## Standard Life's plans to upgrade the track network at Ralia and the Cairngorms National Park

### Description

Map from planning application showing location of road upgrades and ATV tracks. Grey = deep peat. The other colours show outline proposals for tree planting and the land bought by Standard Life.

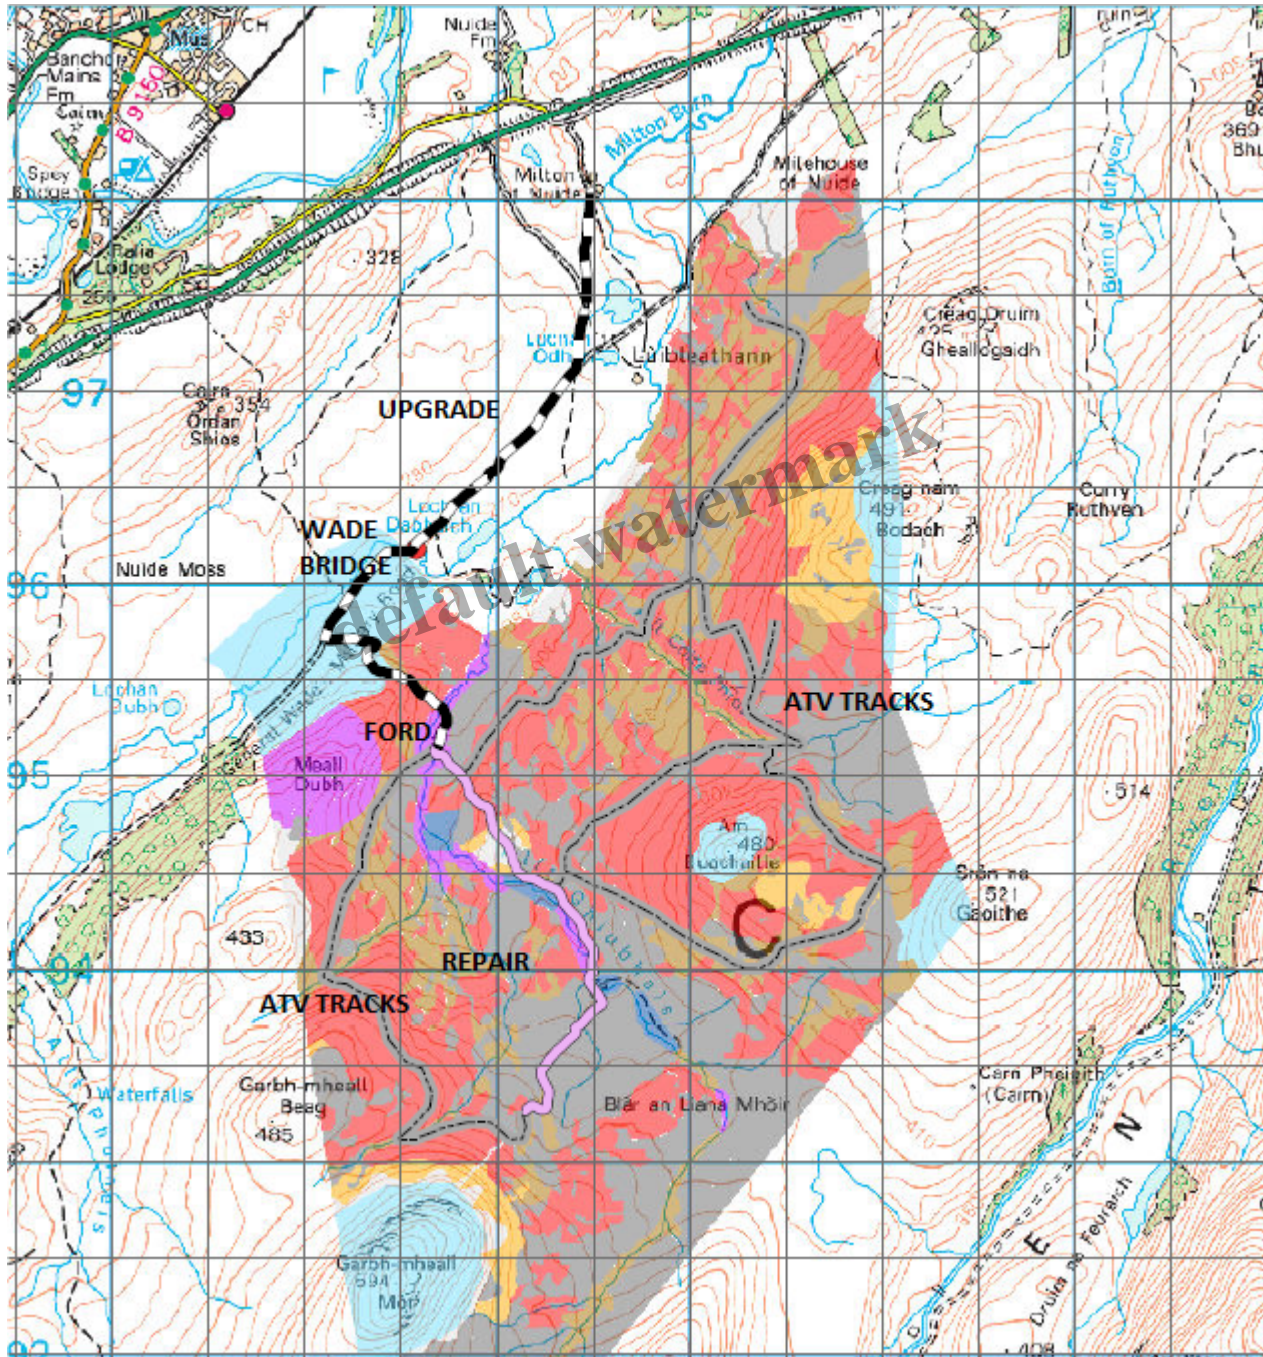
SAC's justification of the upgrade is mince. There is no need for vehicles that are heavier than 4 x 4s to plant trees and the proof of that lies in the supporting statement and the map above. ATVs, not heavy vehicles, will be used to transport trees across the site. The firefighting equipment argument is also nonsense as the 3.5m wide upgrade ends shortly after entering the proposed woodland planting area, meaning that the vast majority of the site would remain inaccessible to fire engines. As for the health and safety and comfort of the people planting trees, modern vehicles have such good suspension that tracks like this pose few issues. SAC consulting should be far more worried about workers on ATVs disappearing into the areas of deep peat crossed by the proposed ATV tracks!

One possibility is that ABDN are also planning to restore areas of peatbog high up, work that normally involves heavy machinery. But if that was the case, why have they not also applied to upgrade rather than repair the higher section of track? Moreover, the map indicates that ABDN are planning to plant this area of bog with trees which, while seriously damaging it releasing large amounts of carbon into the atmosphere, won't require use of heavy vehicles.

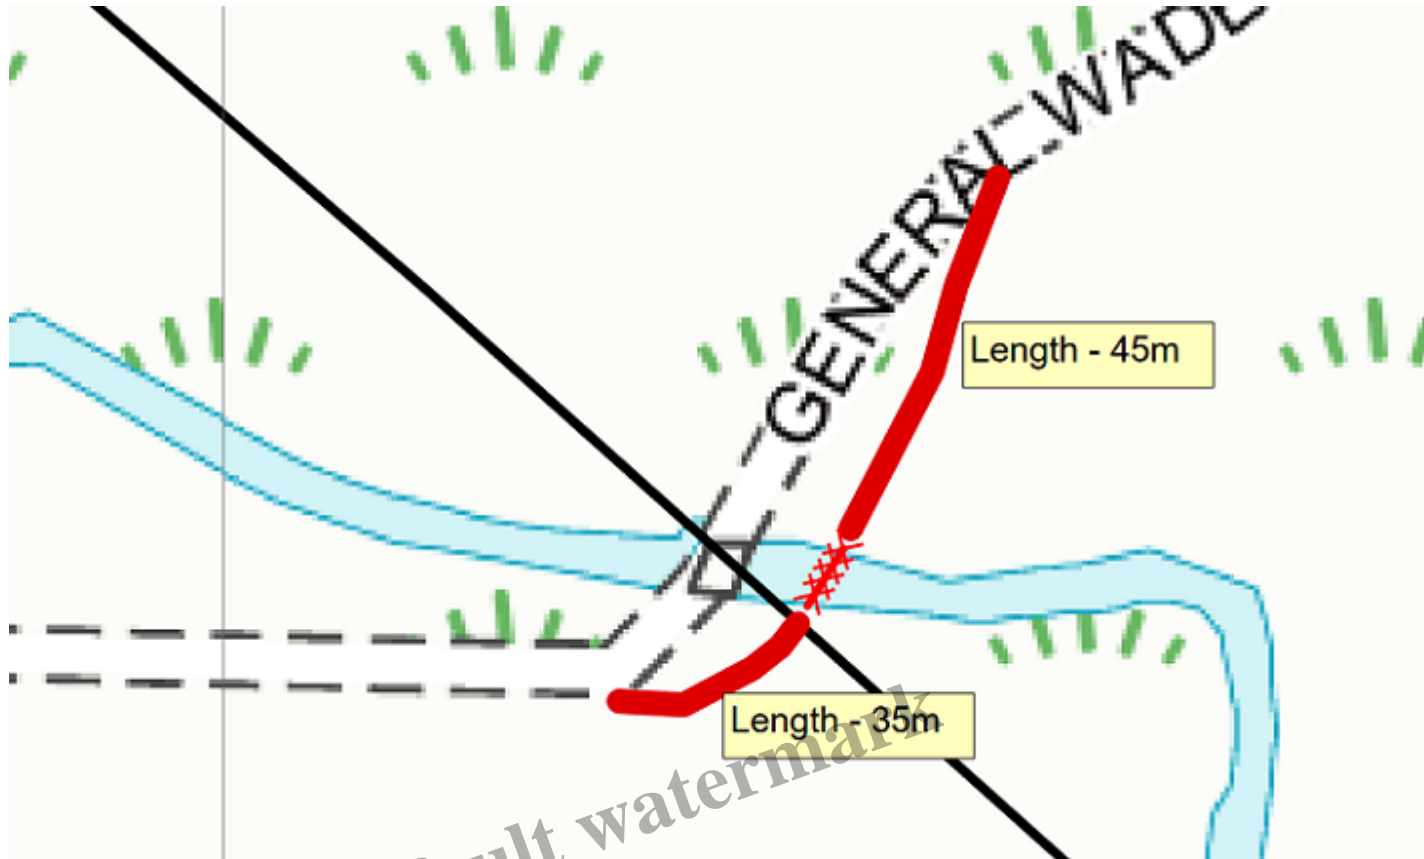
While Wade's bridge, a historic monument, has proved quite adequate for landrovers it could not be used for heavy vehicles and the prior notification includes plans to build a new bridge next door to the existing one. This is crass and takes no account of the historic landscape setting – the CNPA, incidentally, has a statutory duty to conserve the cultural heritage and is at present as far as I am aware still trying to resolve issues created by an erection of an intrusive new gate across the end of the bridge.

Extract from General Plan orientated north

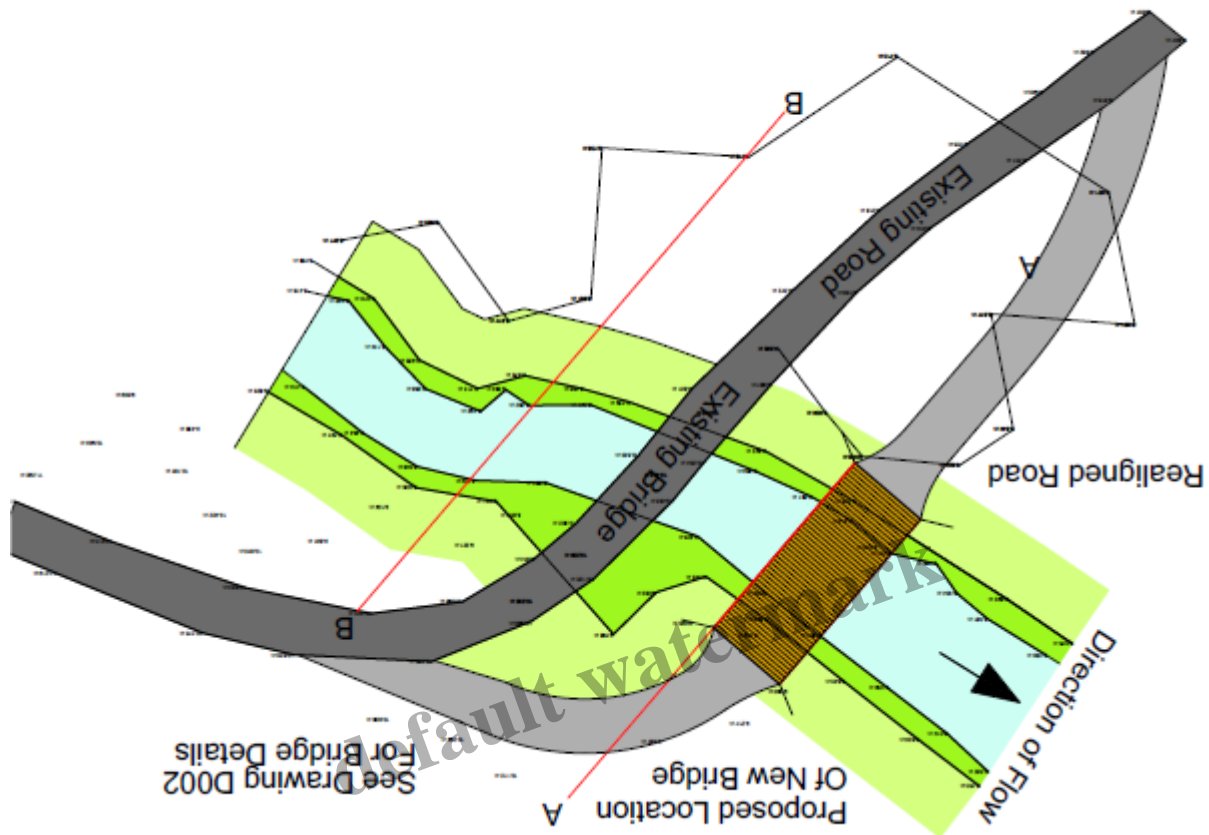
Moreover the plans are far from clear, being orientated in opposite directions

The general plan is dated 26th August and may have pre-dated the gate that has been erected across Wade’s bridge but the developer should have ensured it was included in the plans they have subsequently submitted and explained its purpose.

Figure 1.1 - Existing Road Cross Section

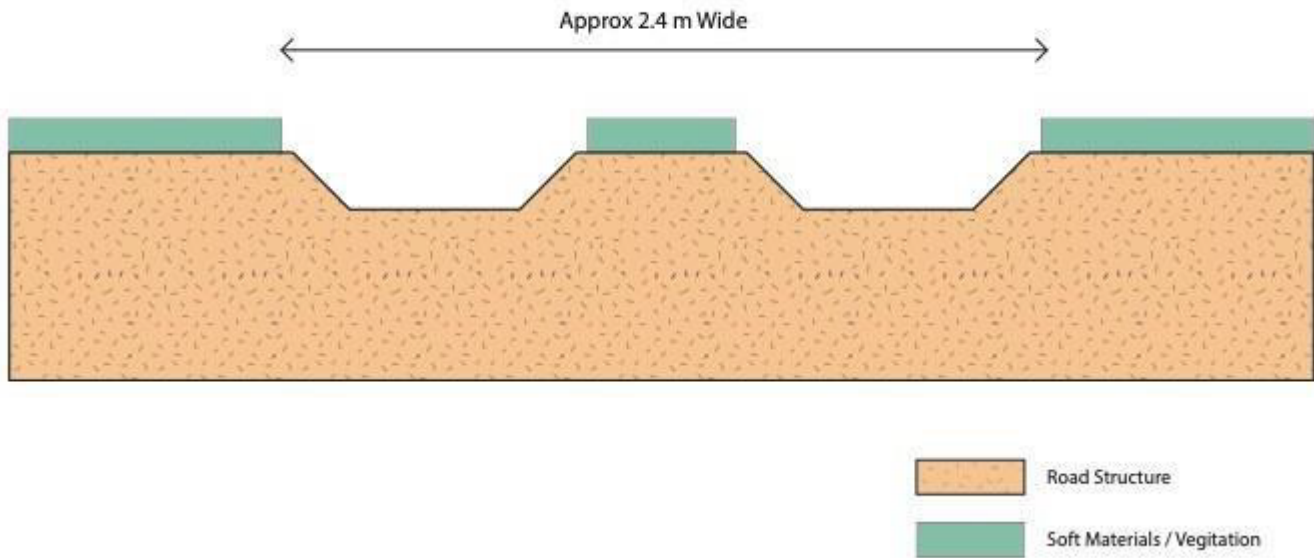
The upgrade proposes to replace a 2.4m wide track which has a vegetated strip running down the middle which in cross section looks like this:

Figure 1.3 - Road Surface Reprofiled and Consolidated

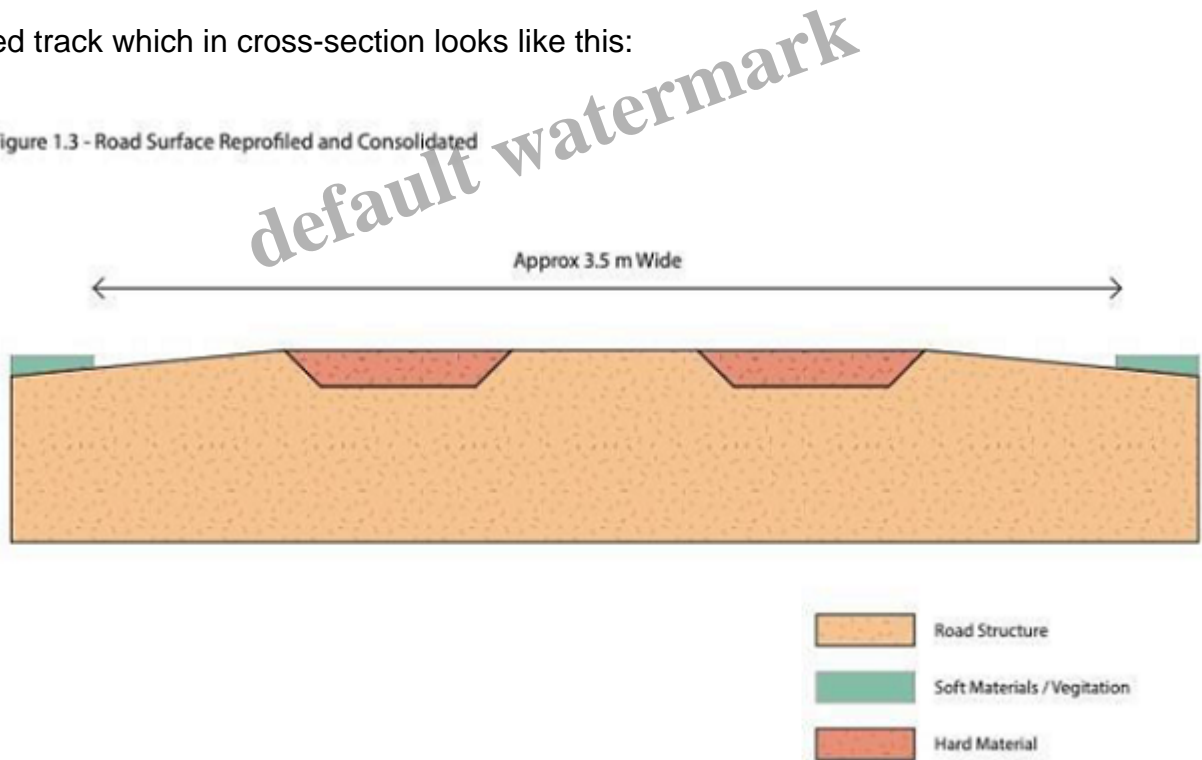
While the Supporting Statement refers to shallow drainage ditches and states “Vegetation will be reinstated on verges as required” this is not shown in the cross sections prepared not by SAC consulting but by Kilrie Trees.

There are some good arguments that raised tracks, which shed water, are preferable to other designs in some places. However, no evidence has been provided that water is causing serious problems on the existing track, possibly because it and the ground beneath it drains well.

Moreover, even if such a track could be justified here, it is too wide, there are no proposals to cover the central strip with vegetation and the plans for the verges are vague. The supporting statement claims “*Useable hard materials from the centre and sides of the road will be used to fill in established running tracks and allow water run off*” but this is likely to affect a considerably wider area than shown in the diagrams as there is not enough material within the footprint of the existing track to create a new higher, broader one. How this will be restored is unclear.
